Inverter Performance – 36A, 36C, 34G, 31UL w/Residential Refer

Bulletin Type:	SRP	Publication Date:	September 2023
Bulletin #(s):	23-117	Make(s):	Jayco, Entegra Coach
Job Code(s):	<i>If affected unit has warranty remaining, submit your claim following the normal process. Repair time allowed should not exceed 2 hours.</i>	Model(s):	Precept (36A-UA, 36C-UC, 34G-UG, 31UL-UL) Vision XL (36A-UA)
Flat Rate(s):		Model Year(s):	2020-2024

Fig. 4

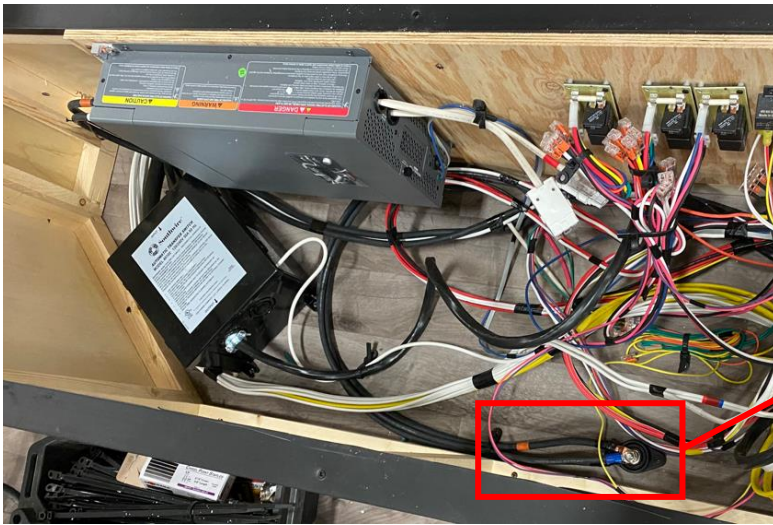
4. Remove the existing cables running between the inverter and the battery and discard. (Fig. 4)
 - a. Ground cable runs from the inverter to the frame. This can be left in place and taped off (not to be used).
 - b. Positive cable (Black 2GA with Orange tape) runs from the inverter to the standoff terminal stud in the bed base. This will need to be removed.

Fig. 5

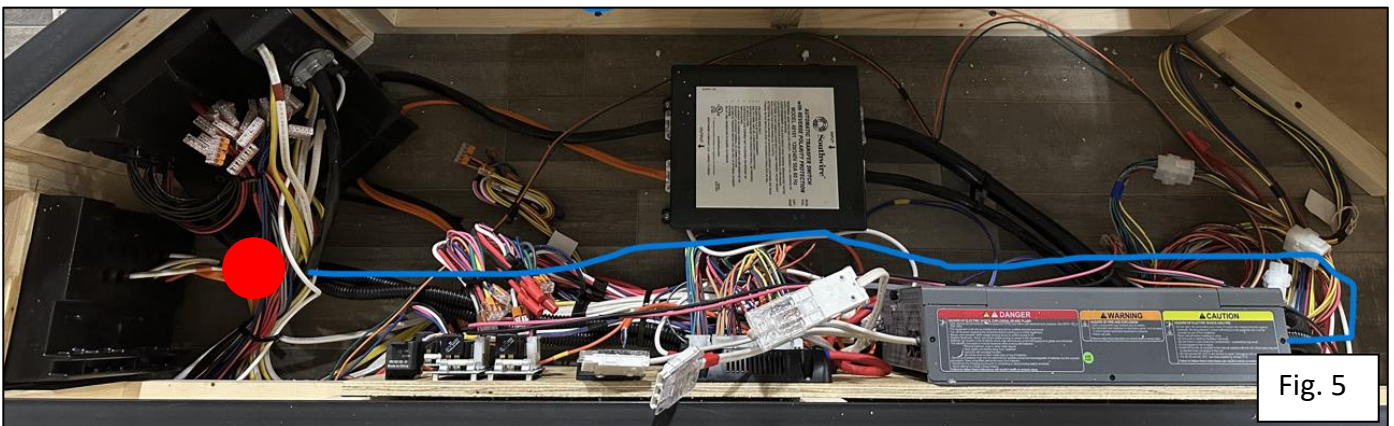
5. Drill a 2" hole through the floor between the two load centers. (Fig. 5)
 Caution: Wire harnesses will need to be moved
 Caution: Depending of floor plan, the fuel tank under the vehicle will determine the exact hole location.

Fig. 6

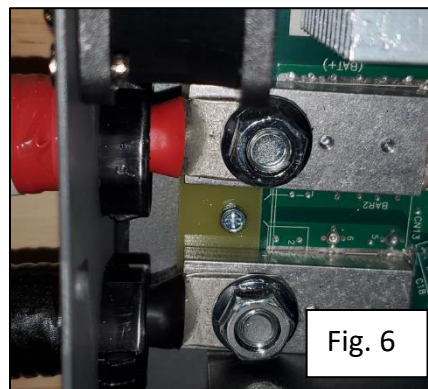
6. Following the existing cable routing, route the new heavier gauge cables from the inverter down to the battery box.
7. Inverter Connections (Fig 6):
 - a. With a 1/2" socket, connect the 96" negative (Black) cable (Torque = 71-80 LBF-IN).
 - b. With a 1/2" socket, connect the 96" positive (Red) cable (Torque = 71-80 LBF-IN).
 - c. Re-install the access panel.

8. Manual Reset Breaker Connections (Fig. 7):

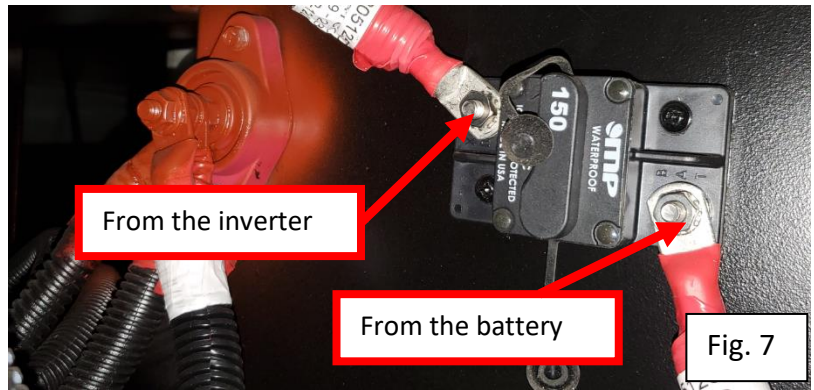
- d. In the battery box, add a 150A Manual Reset Breaker to the side of the battery compartment next to the positive mounting stud. Secure to the box with two self-tapping screws
- e. Using a 7/16" socket, connect the positive (Red) cable from the inverter to the AUX side of the reset breaker (Torque = 24 LBF-IN).
- f. Using a 7/16" socket, connect the 36" Red battery cable to the BAT side of the reset breaker (Torque = 24 LBF-IN).

9. Battery Connections (Fig. 8):

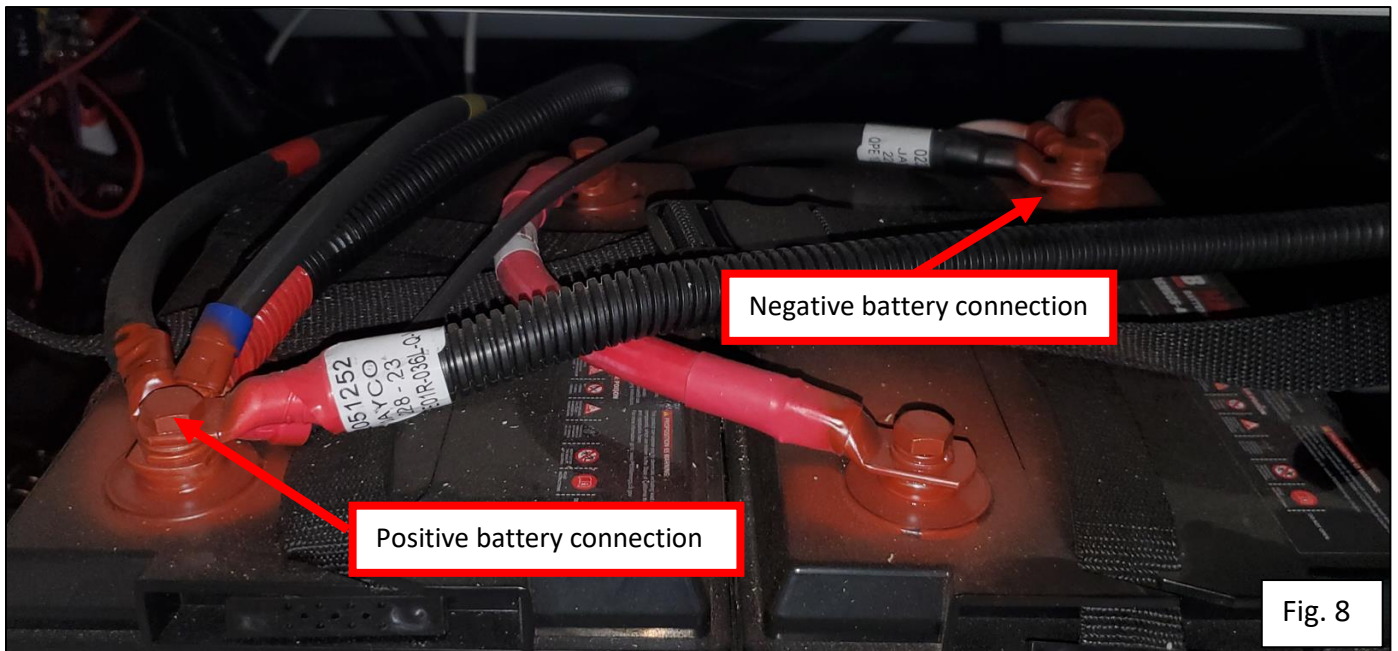
- a. With a 1/2" socket, connect the opposite end of the 36" Red battery cable from reset breaker to positive terminal (Torque = 50-70 LBF-IN)
- b. With a 1/2" socket, connect the negative cable from the inverter to negative terminal (Torque = 50-70 LBF-IN)
